ADDENDUM NO. 07

Baggage Screening Improvements – Phase 2A
[Loading Dock Reconfiguration, Sheriff’s Checkpoint Removal, Jetway Installation
(Gate 30, 46, 47), IAB Airside Trash Remodel, North Checkpoint Relocation]

PROJECT NO. A044-09002

GENERAL MITCHELL INTERNATIONAL AIRPORT
Milwaukee County, Wisconsin

A301A

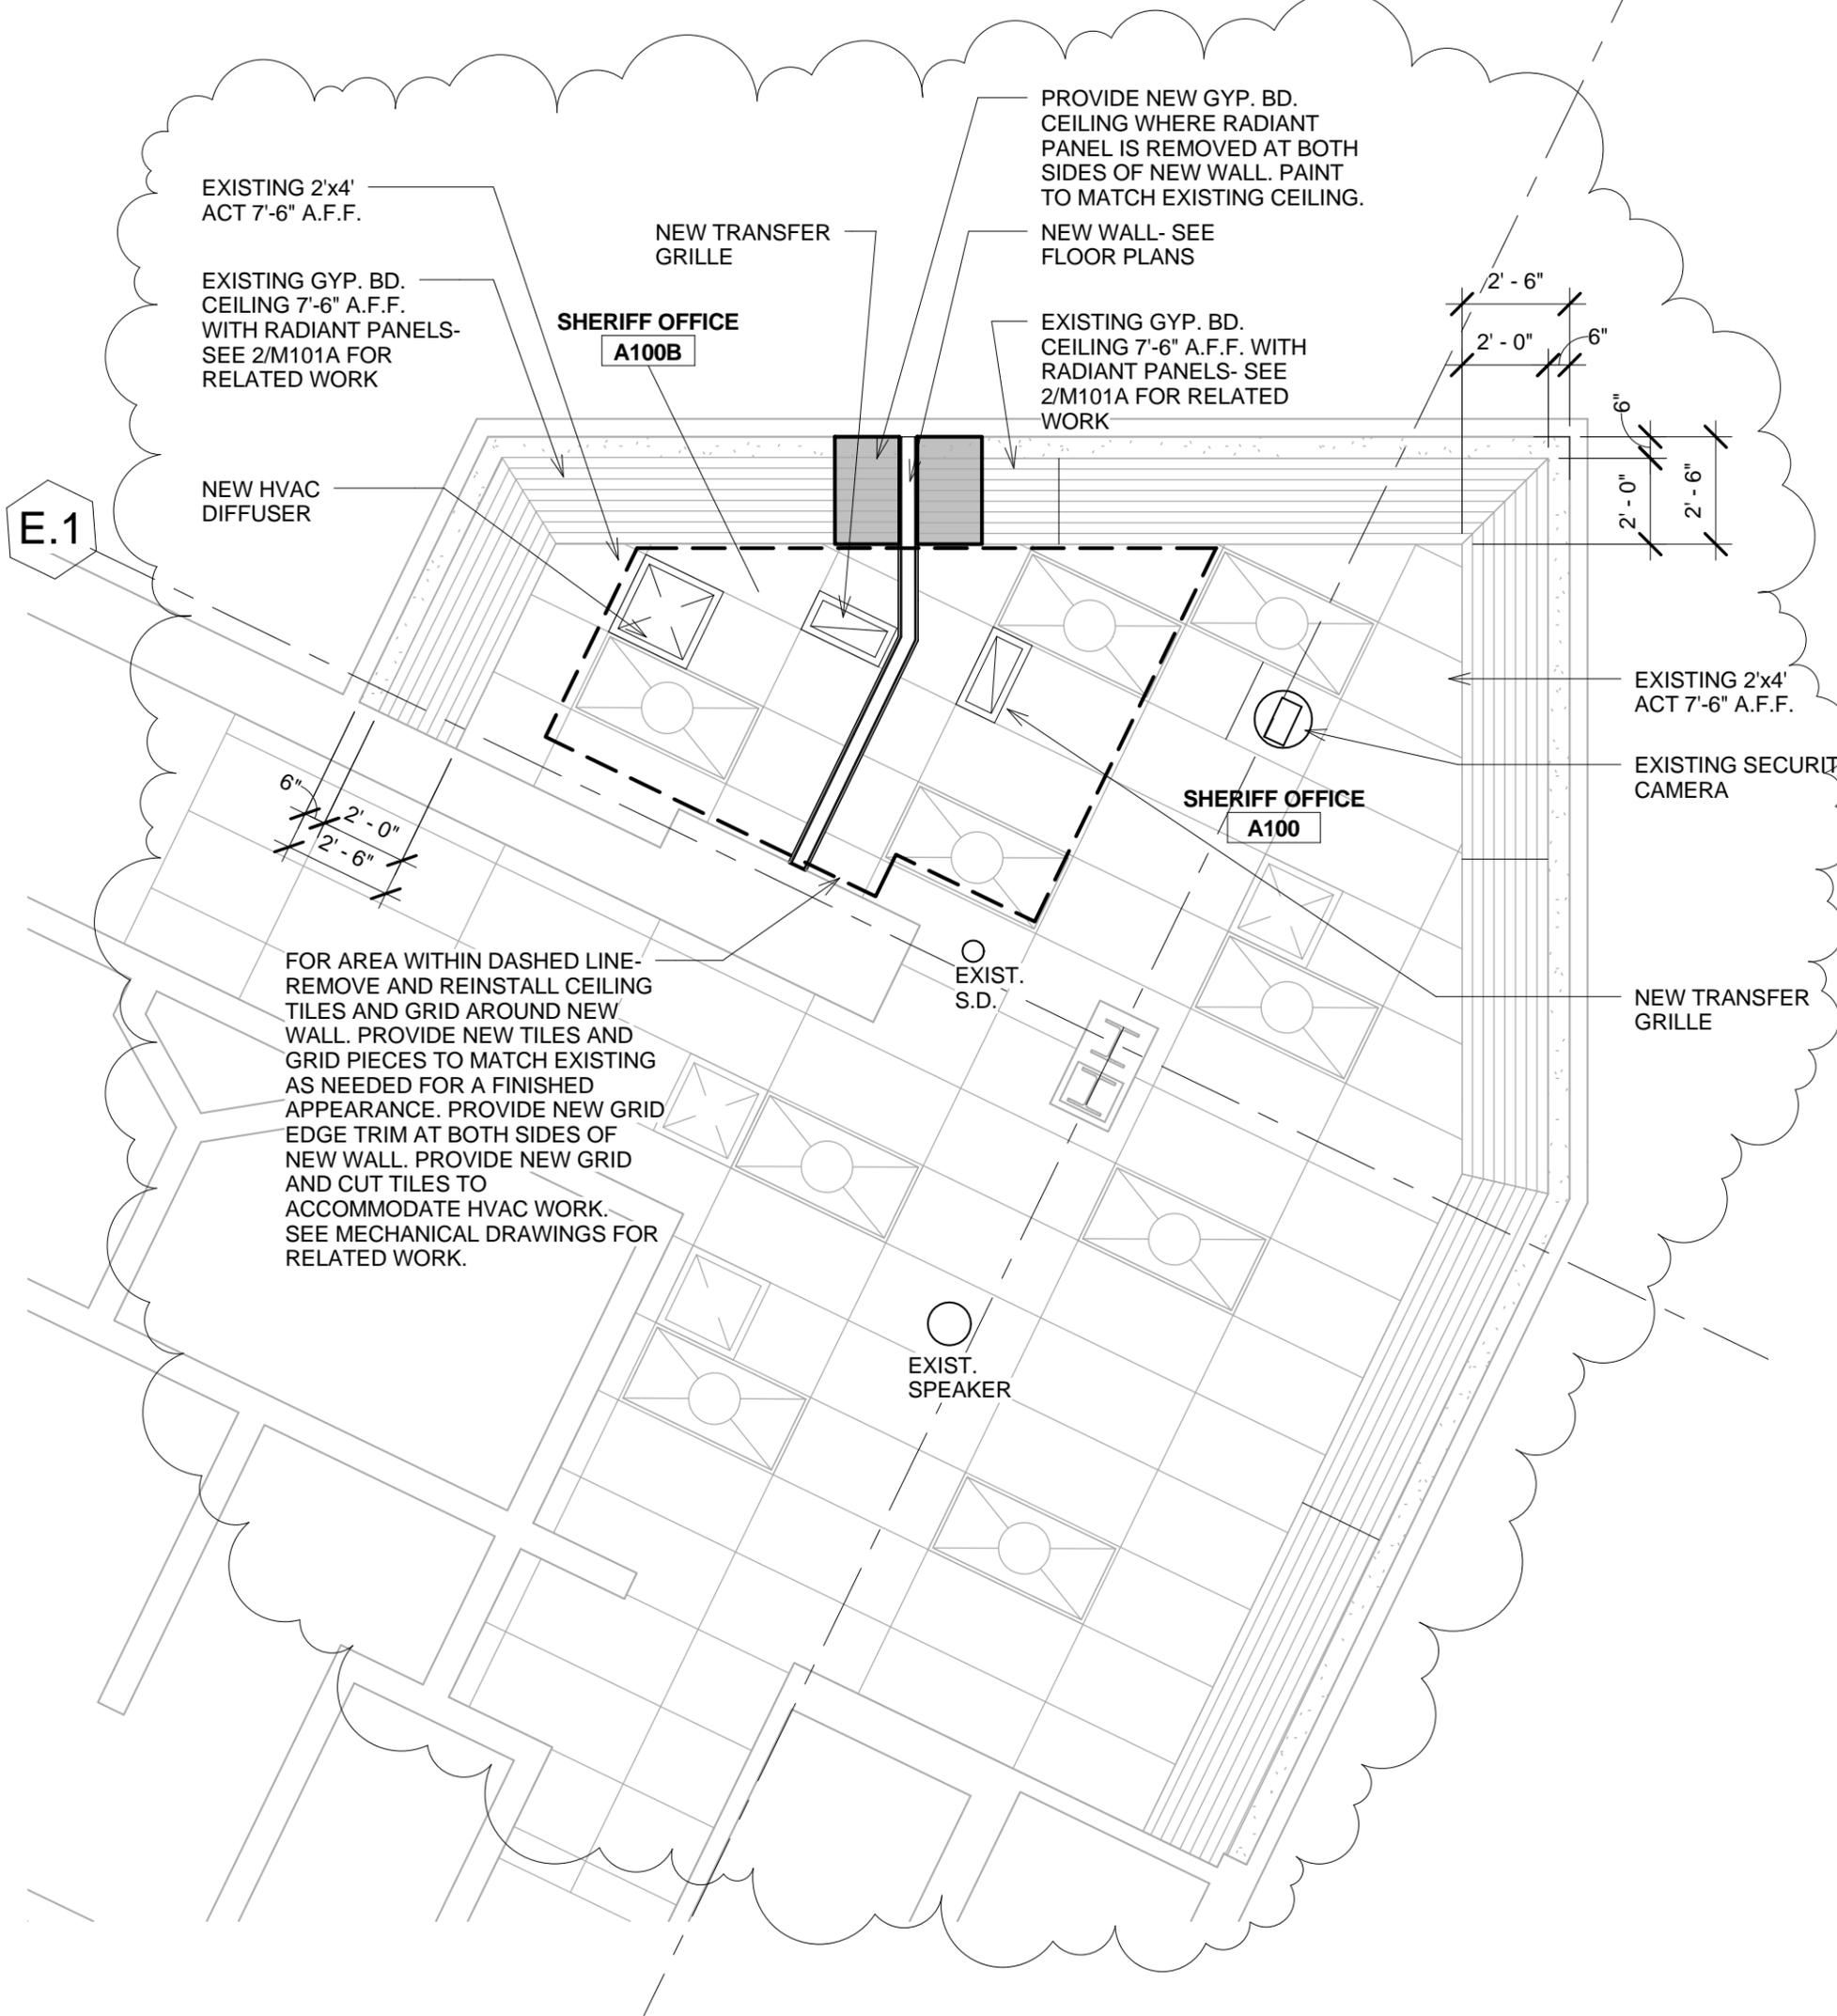
- ADD gypsum board ceiling patching and associated note to read as follows.

PROVIDE NEW GYP. BD. CEILING WHERE RADIANT PANEL IS REMOVED AT BOTH SIDES OF NEW WALL. PAINT TO MATCH EXISTING PAINT TO MATCH EXISTING ADJACENT GYP. BD. CEILING.
- REVISE existing note, in two locations, to read as follows.

EXISTING GYP. BD CEILING 7' – 6" A.F.F. WITH RADIANT PANELS – SEE 2/M101A FOR RELATED WORK.
- ADD note outlining the scope of ceiling work to read as follows.

FOR AREA WITHIN DASHED LINE – REMOVE AND REINSTALL CEILING TILES AND GRID AROUND NEW WALL AND NEW MECHANICAL GRILLES PROVIDE NEW TILES AND GRID PIECES TO MATCH EXISTING AS NEEDED FOR FINISHED APPEARANCE. PROVIDE NEW GRID EDGE TRIM AT BOTH SIDES OF NEW WALL, LIGHT FIXTURES AND GRILLES. PROVIDE NEW GRID AND CUT TILES TO ACCOMMODATE LIGHT FIXTURE RELOCATION. SEE ELECTRICAL AND MECHANICAL DRAWINGS FOR RELATED WORK.

E102A

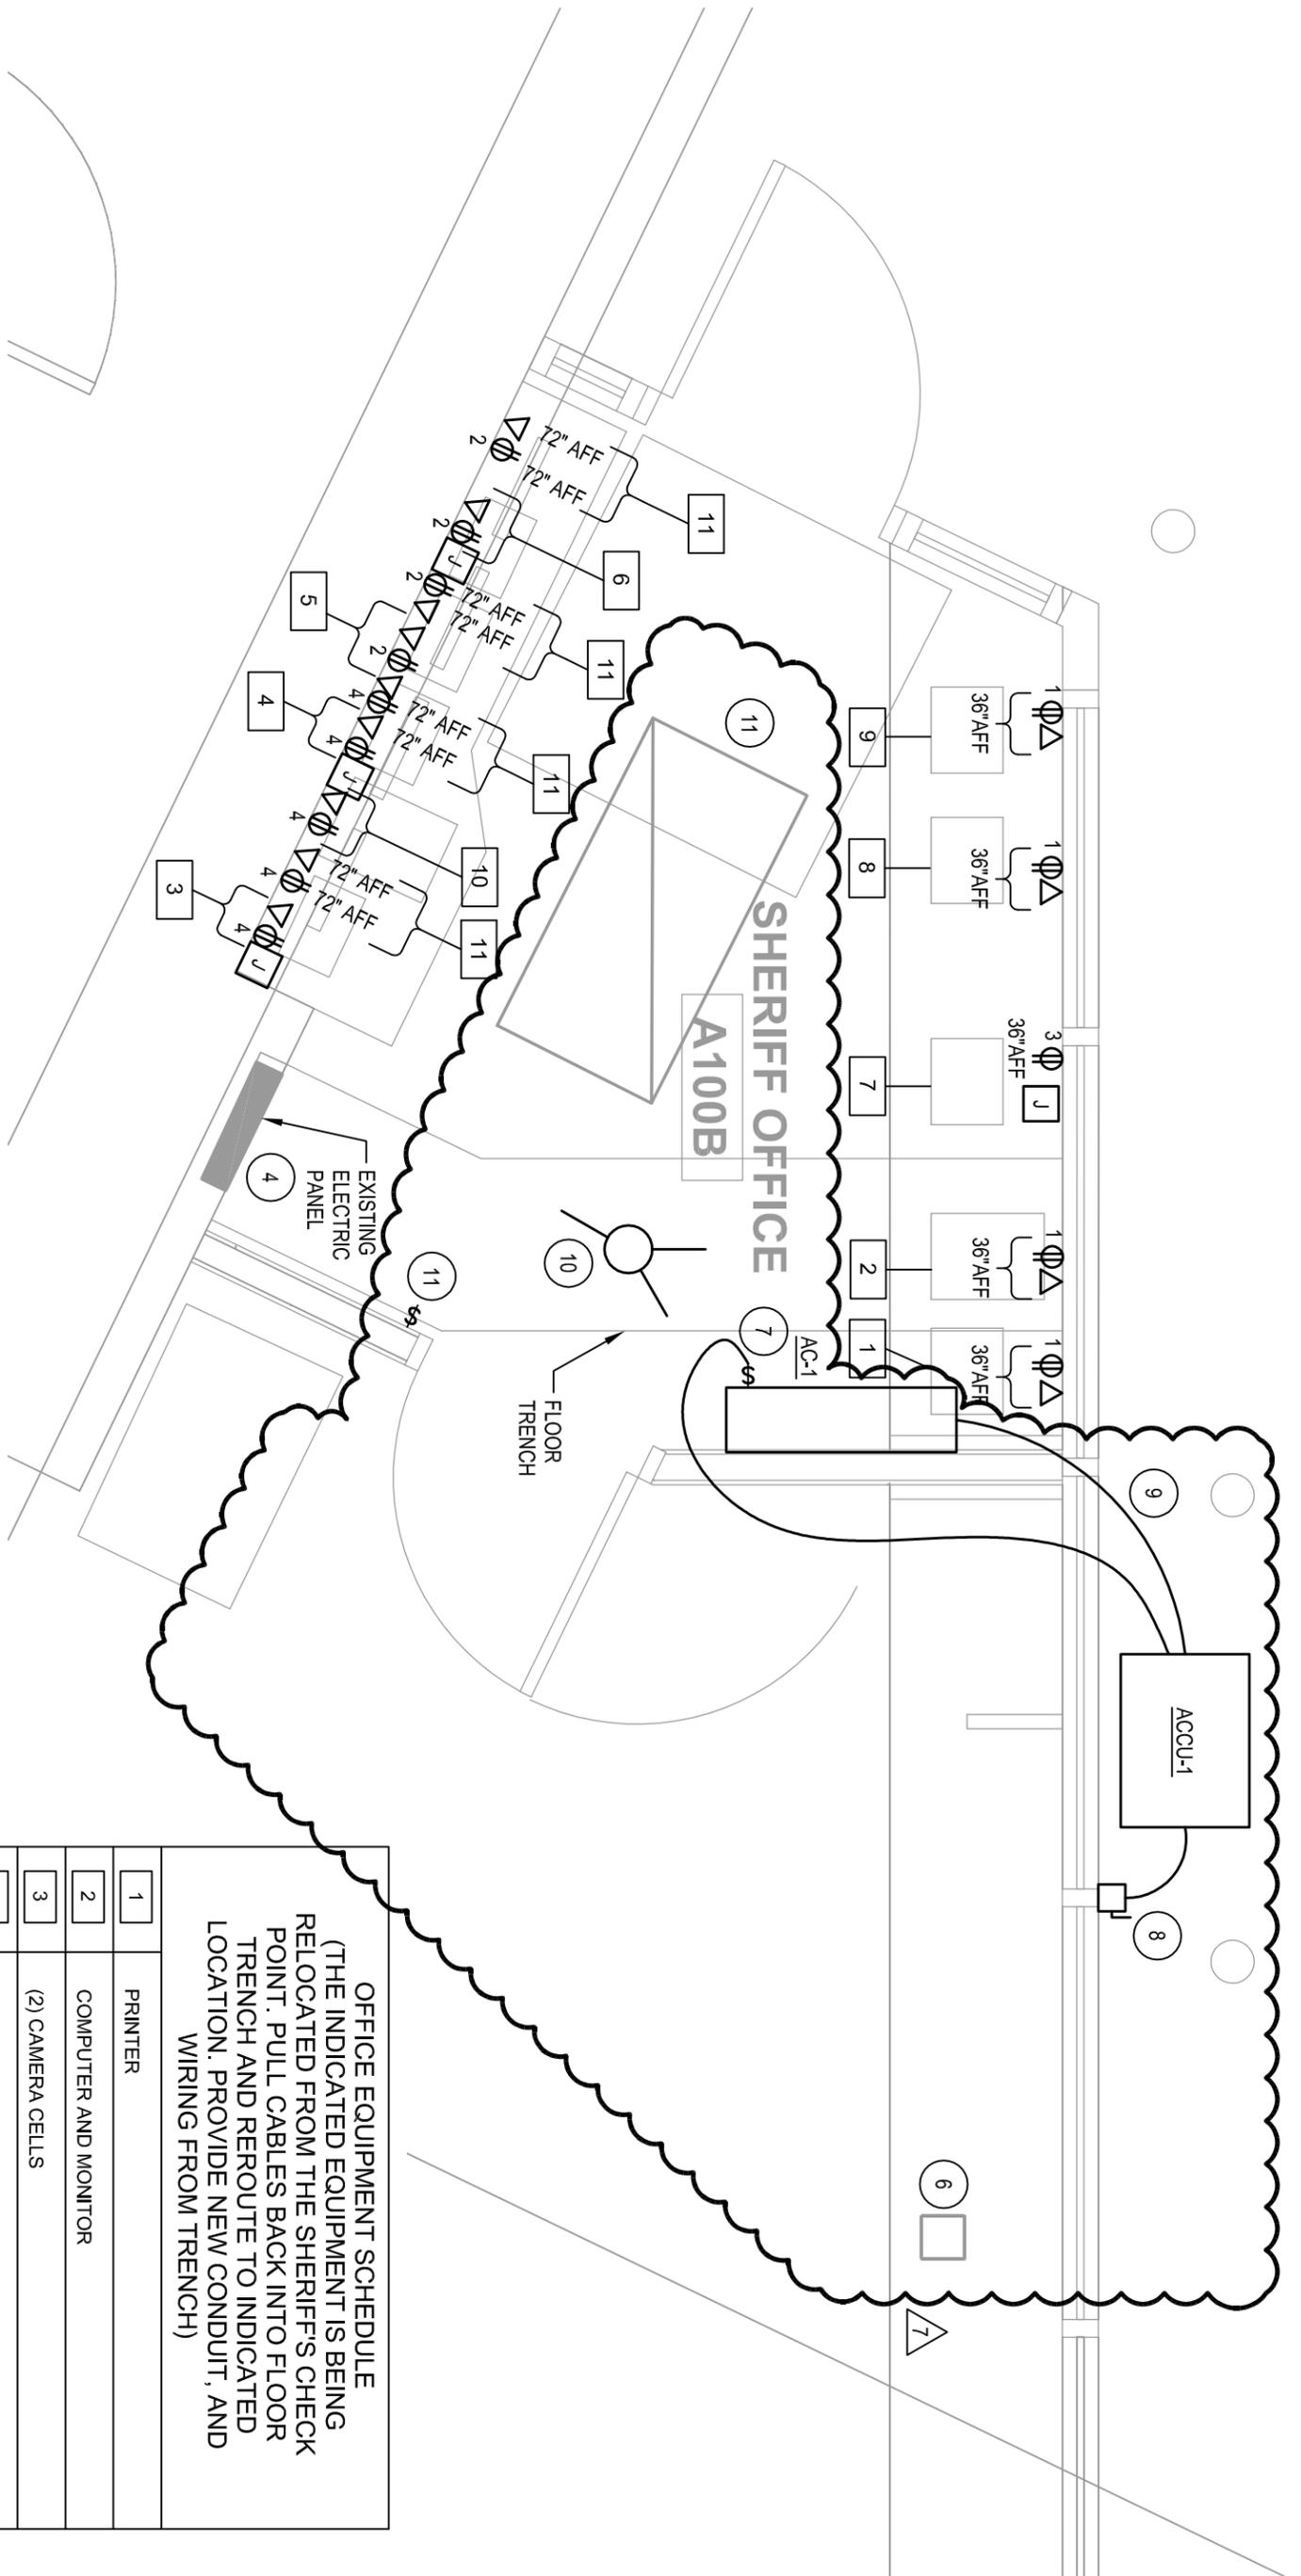
- Reconnect existing fixture in new room to new switch in wall.
- Provide new antenna in the ceiling cavity for the relocated radio.

- Extend existing connection for the desktop telephone which monitors the radio system. Existing cabling is routed to the Sheriff's Checkpoint through the in-floor conduit. Reroute cable to the radio system.
- Provide conduit, wiring and connections to the HVAC equipment for the new space.

- ① CONNECT TO EXISTING CIRCUIT.
- ② PROVIDE NEW LOOP DETECTOR IN NEW CONCRETE SLAB. REFER TO DETAIL 1/E700A FOR FURTHER INFORMATION.
- ③ PROVIDE 3/4" RIGID METAL CONDUIT FROM LOOP DETECTOR TO CONTROLS FOR GARAGE DOOR. COORDINATE WITH GARAGE DOOR SUPPLIER.
- ④ CIRCUITING IS SHOWN FOR INTENT ONLY. CONNECT TO EXISTING CIRCUIT BREAKERS IN EXISTING PANEL IN SHERIFF'S OFFICE.
- ⑤ PANEL "B" IS AN EXISTING 120/2008 VOLT PANEL IN THE IAB BUILDING.

- ⑥ RECONNECT EXISTING TELEPHONE TO NEW RADIO EQUIPMENT.
- ⑦ PROVIDE MOTOR RATED TOGGLE SWITCH DISCONNECT FOR INDOOR SPLIT SYSTEM UNIT. PROVIDE 2#12, #12 GND IN 3/4" CONDUIT TO OUTDOOR UNIT FOR POWER.
- ⑧ PROVIDE 2-POLE NEMA-3R DISCONNECT FOR OUTDOOR CONDENSING UNIT. PROVIDE 2#12, #12 GND IN 3/4" CONDUIT TO LOCAL PANEL IN SHERIFF'S OFFICE. PROVIDE 2-POLE BREAKER IN LOCAL PANEL.
- ⑨ PROVIDE 3/4" CONDUIT FOR LOW VOLTAGE WIRING BETWEEN OUTDOOR AND INDOOR UNITS.
- ⑩ PROVIDE NEW 800 MHZ RADIO ANTENNA ABOVE CEILING FOR RELOCATED RADIO. EXACT LOCATION SHALL BE VERIFIED IN FIELD. COORDINATE ANTENNA INSTALLATION AND TESTING WITH CLYDE GASSSEL AT 414-278-5142. ANTENNA SHALL BE INSTALLED AND TESTED PRIOR TO RELOCATION OF RADIO.
- ⑪ DISCONNECT EXISTING FIXTURE FROM ROOM SWITCHES AND CONNECT TO NEW SWITCH IN NEW WALL.
